**Meeting of the Central Valley Flood Protection Board
July 27, 2012**

Staff Report – Encroachment Permit No. 18653

**California Department of Transportation, District 3
State Route 65 (Lincoln Bypass) Bridges over Auburn Ravine
City of Lincoln, Placer County**

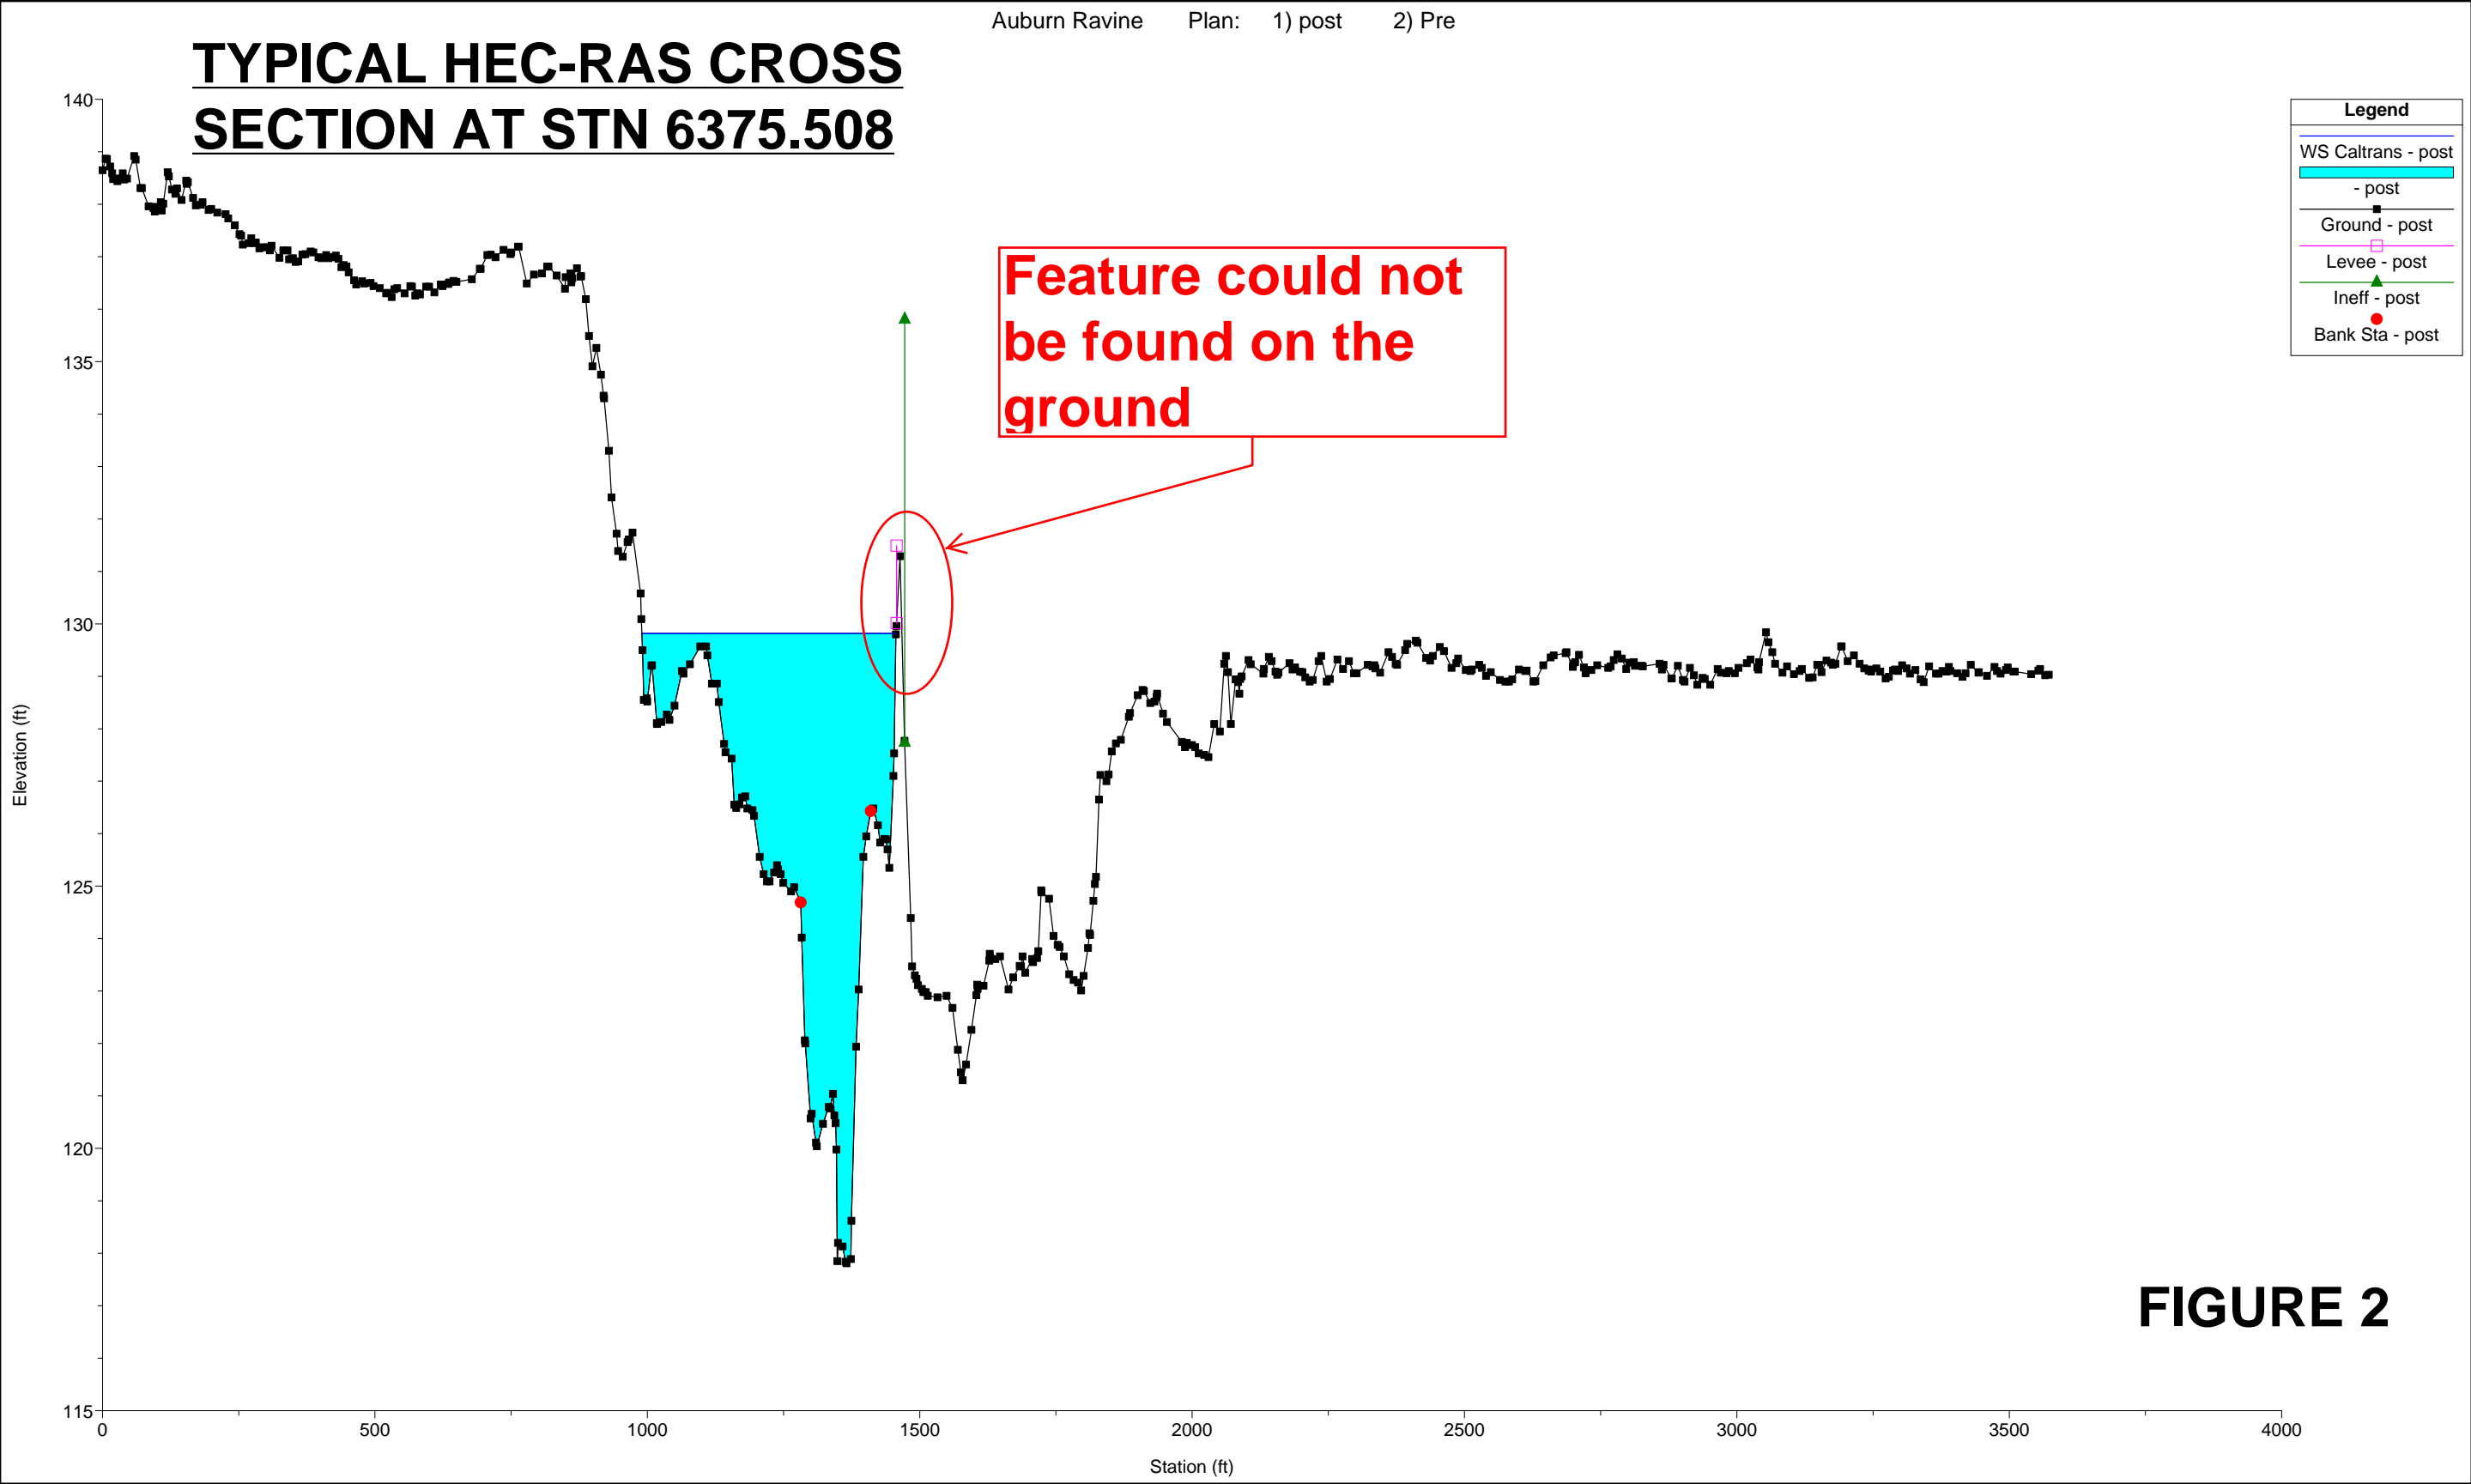
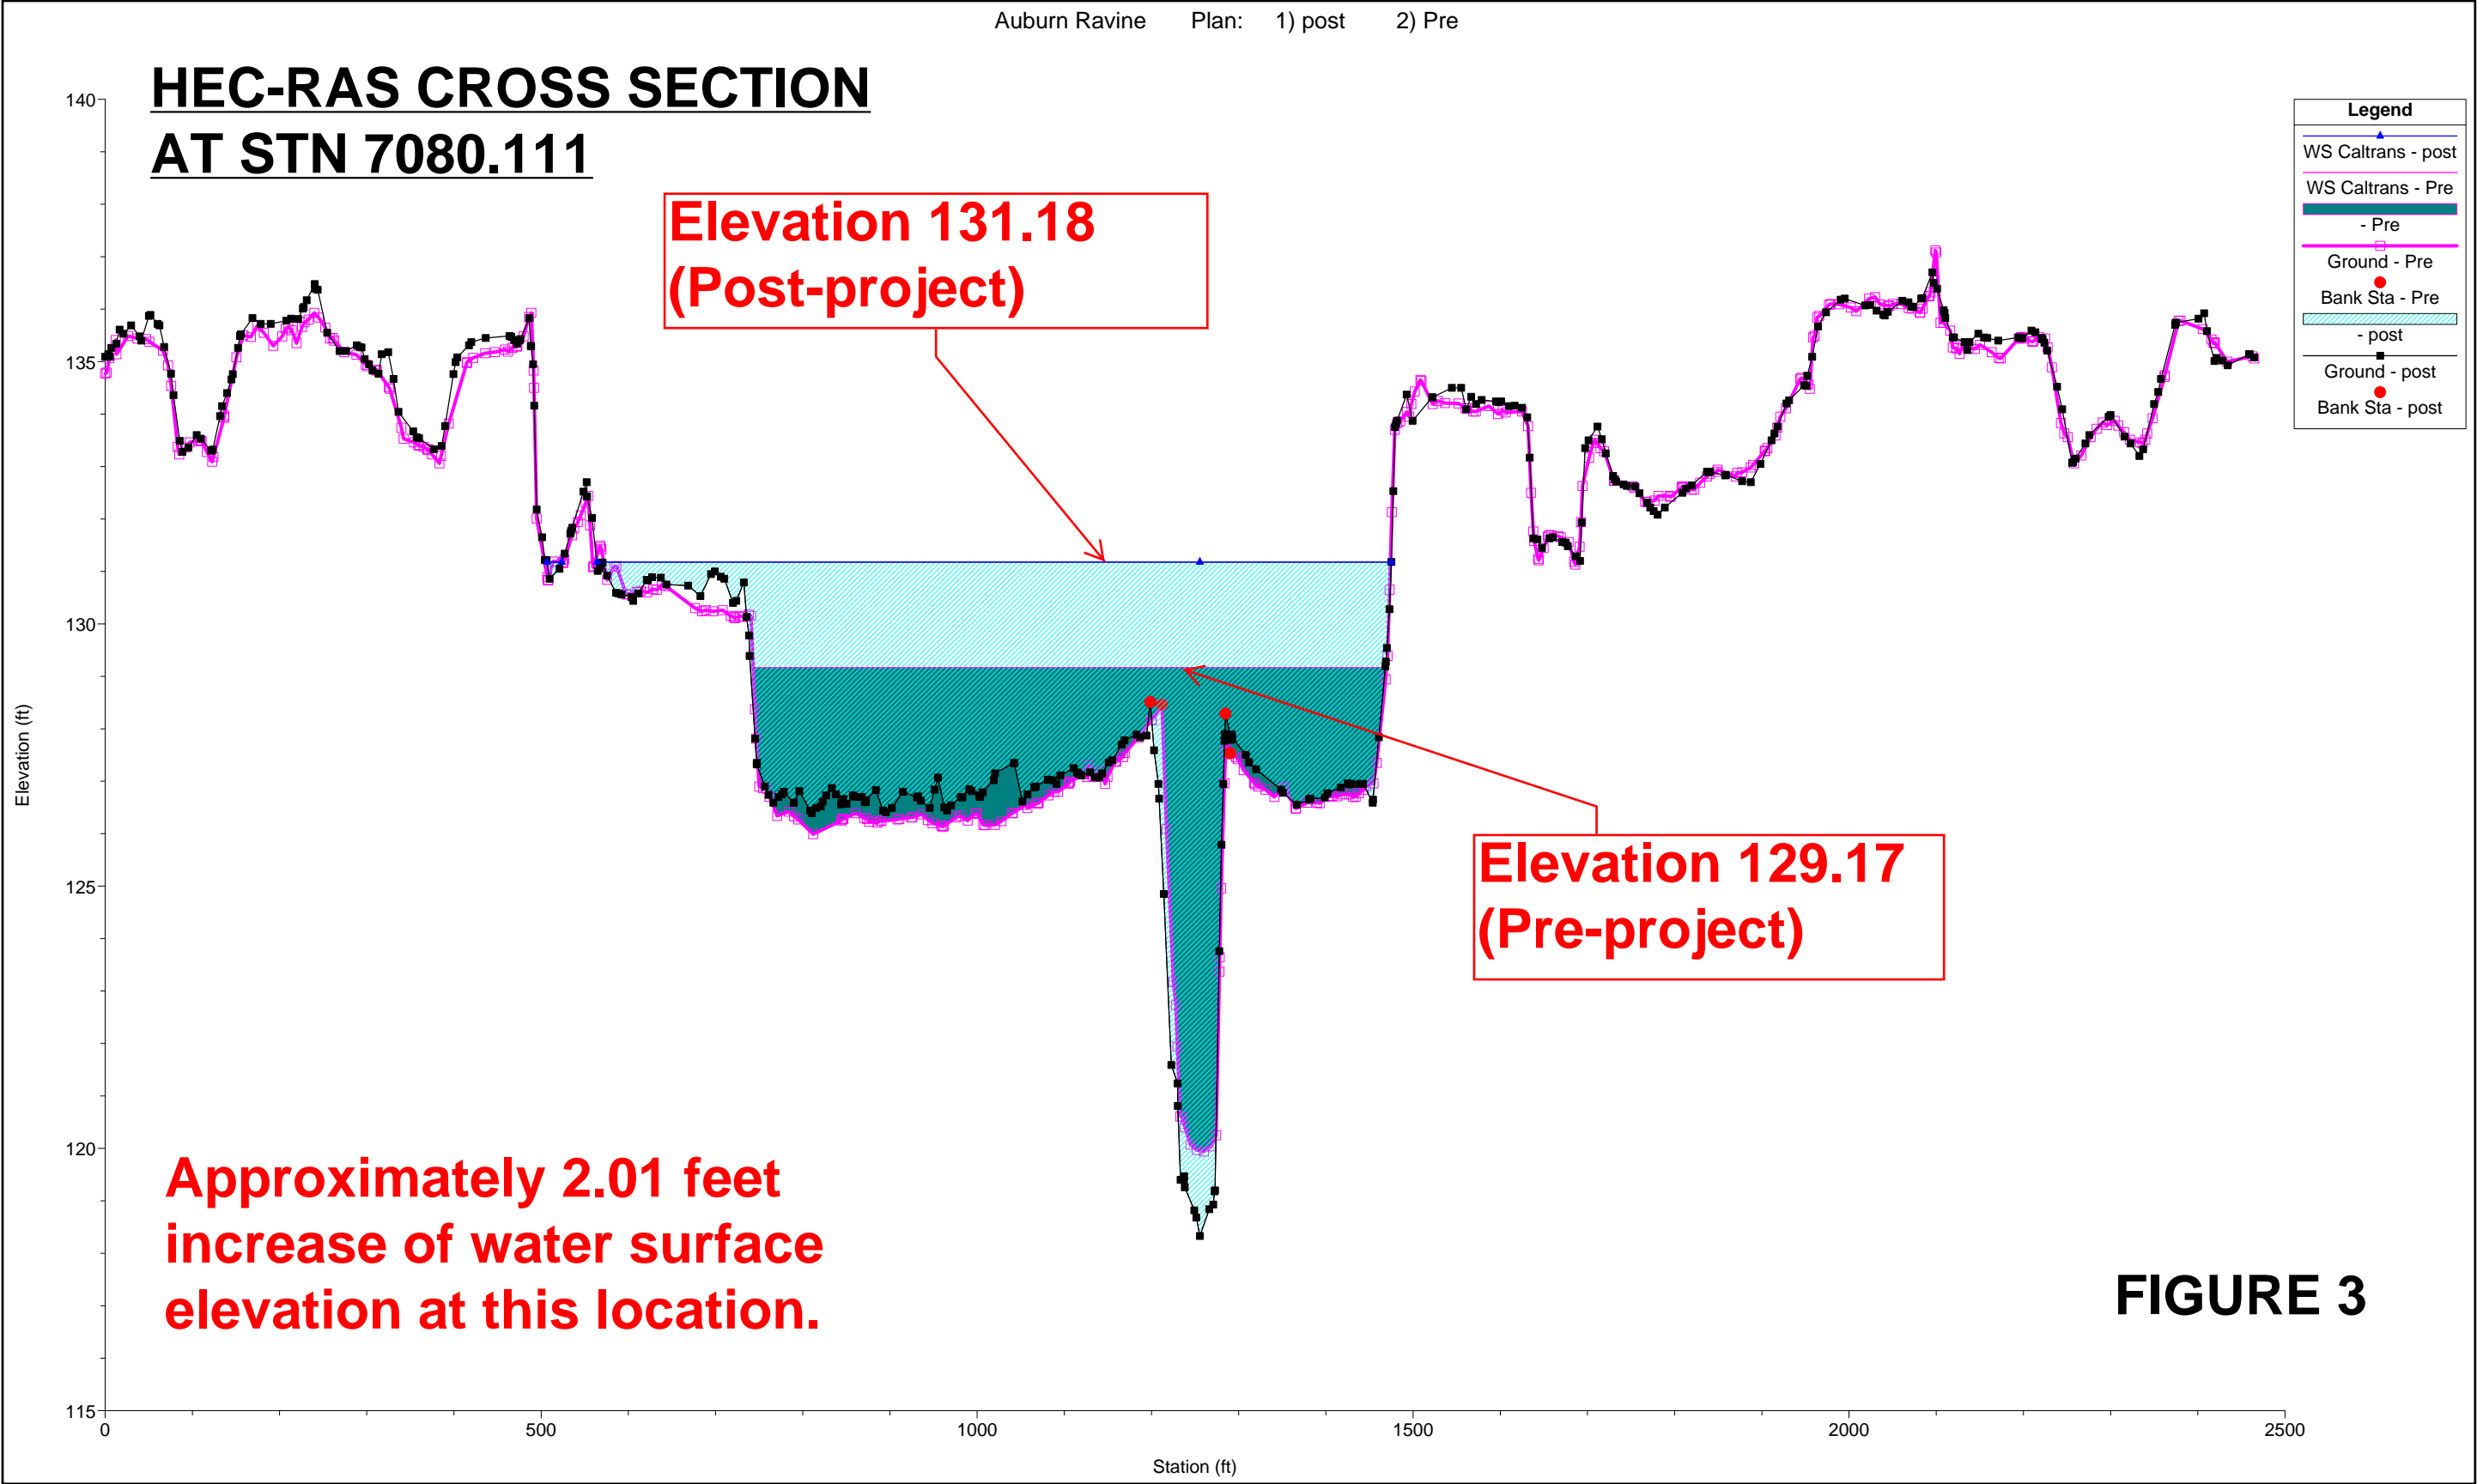
Board staff also believes there may be errors in certain cross-sections used in the hydraulic models (see Attachment E, Figure 2, cross section 6375.508 and one other). Staff visited the site on July 3, 2012 and could not locate this high ground in the field. The feature constrains floodwaters within the channel when modeled, but based on the field visits no feature exists and actual flooding would further inundate lands to the north.

Caltrans has claimed that the incremental hydraulic impacts to the orchard (depth of flooding) due to bridge construction are insignificant, and has requested the permit application be approved based their supporting justification (See Attachment E).
